VARIANCE REQUEST

Iowa Department of Natural Resources

15. Description of Variance Request

Retain submerged flow split approach
for two existing clarifiers.

MODIFIED CLARIFIER SPLITTER BOX
SCALE 1/4"=1'

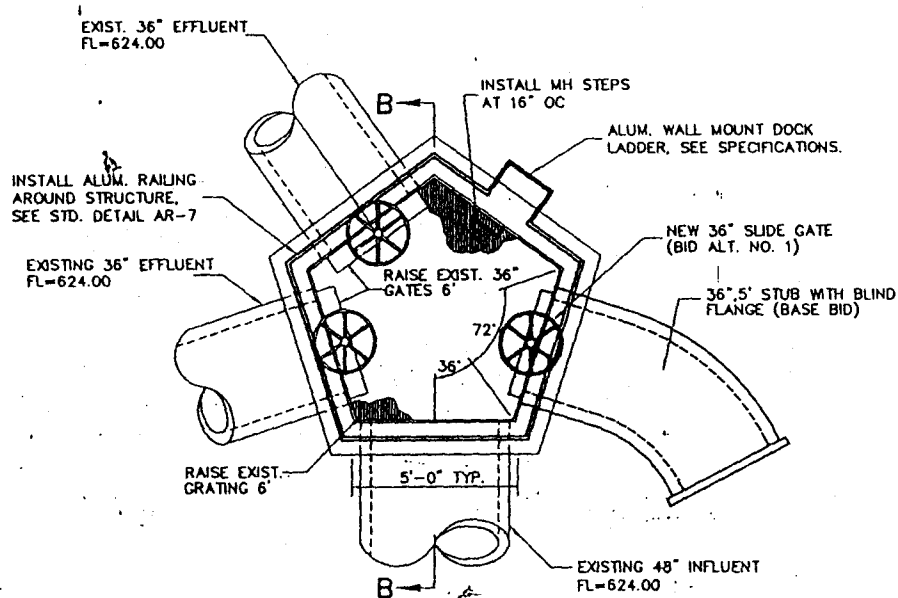
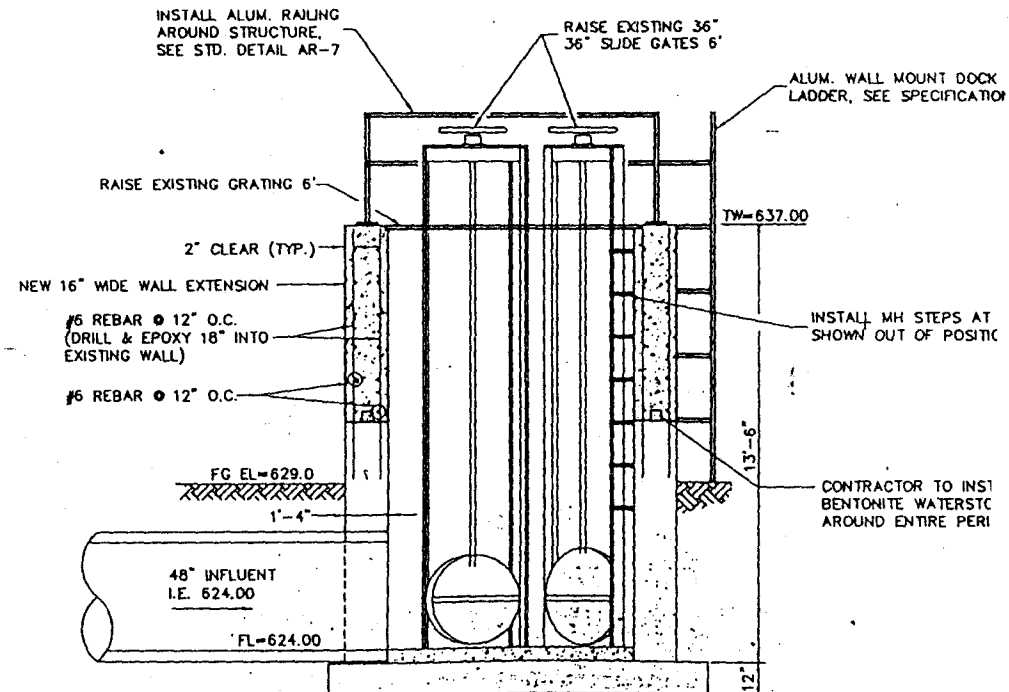
No noticeable flow variation can be
detected between the two clarifiers.

Although the structure is being modified
the function it is performing remains the
same.

Flow splitting control for even splits of hydraulic and solids loading with the proposed structure is very difficult. Design standard 14.4.9.3 clearly was written to prevent designs similar to the Ottumwa approach. More clarifiers may be added in the future as the structure is designed for the addition of more units. With the design as proposed it is impossible to have equal flow splits for a wide range of flows unless the operator is there continually adjusting.

Even if he balances out the hydraulic loadings it is unlikely the solids loadings will be balanced to

Deny Variance
